IGroundwater Application Review Summary Form

Application # G- 19065 re-review

GW Reviewer Travis Brown Date Review Completed: 5/8/2023

A. GENERAL INFORMATION: Applicant's Name: Lisa Johnson / Sunset Farms County: Lane

Well Location Map

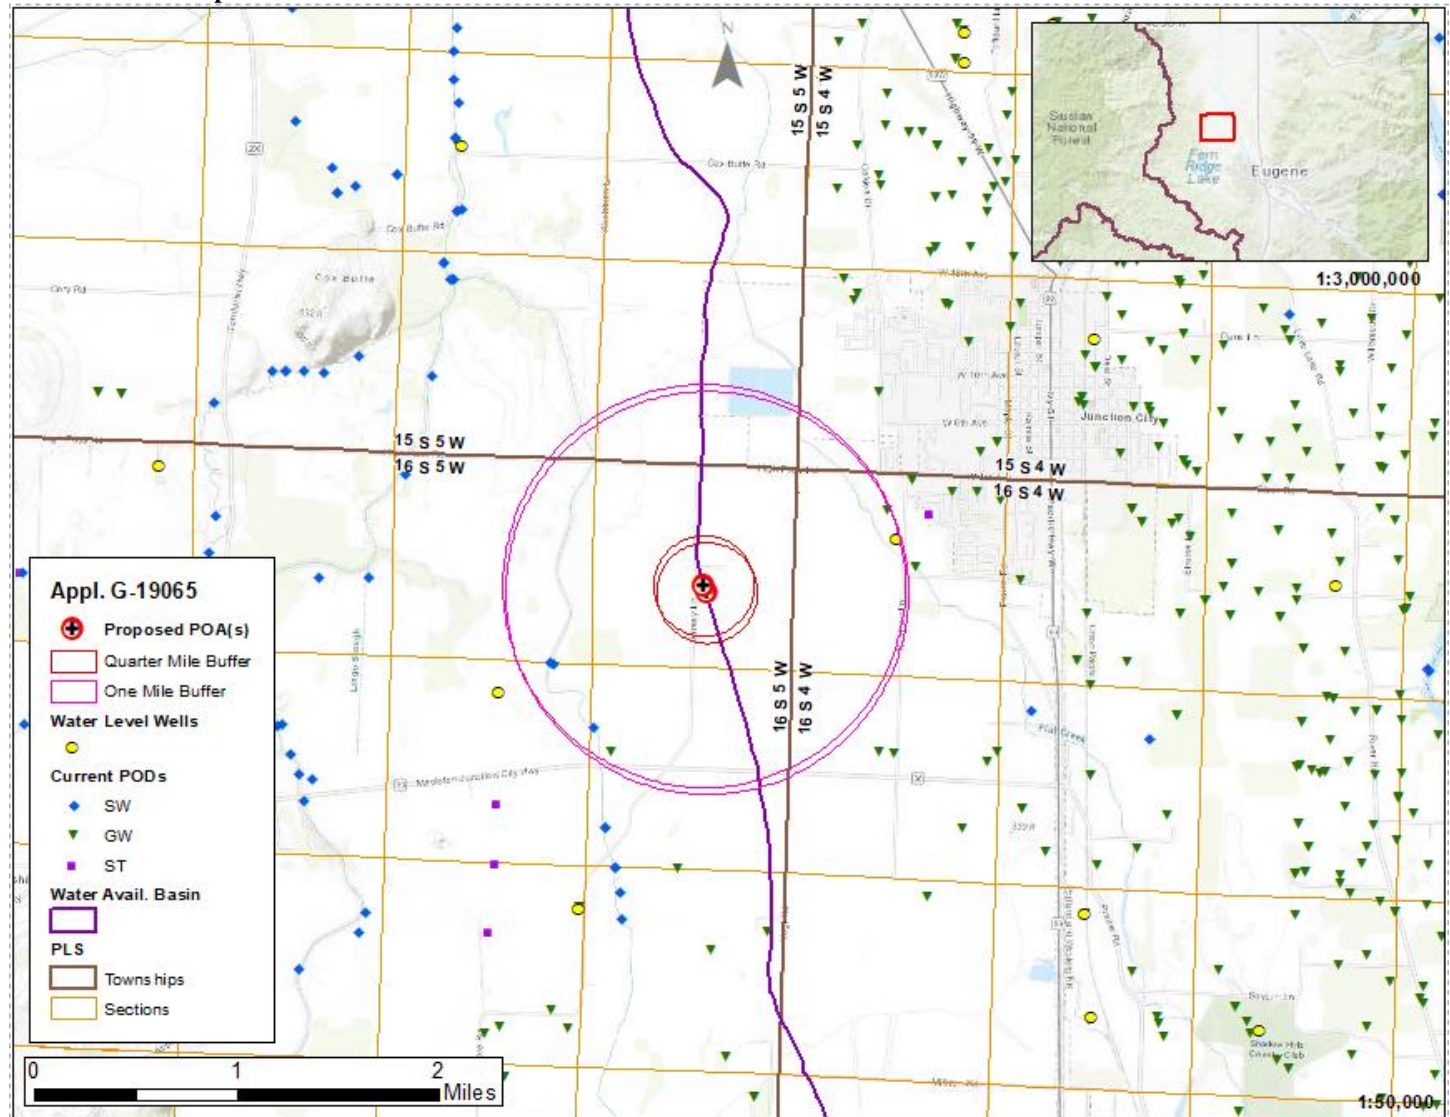
Well	Logid	Applicant's Well #	Proposed Aquifer*	Proposed Rate(cfs)	Location (T/R-S QQ-Q)	Location, metes and bounds, e.g. 2250' N, 1200' E fr NW cor S 36
1	LANE0008397	1	Alluvium	0.31	16.00S-5.00W-1-NW SE	520 FEET SOUTH AND 260 FEET EAST FROM C1/4 CORNER, SECTION 1
2	PROPOSED	2	Alluvium	0.31	16.00S-5.00W-1-NW SE	704 FEET SOUTH AND 337 FEET EAST FROM C1/4 CORNER, SECTION 1
3						
4

A4. **Comments:** POD #2 is a proposed well but should encounter similar hydrologic and geologic conditions as POD #1
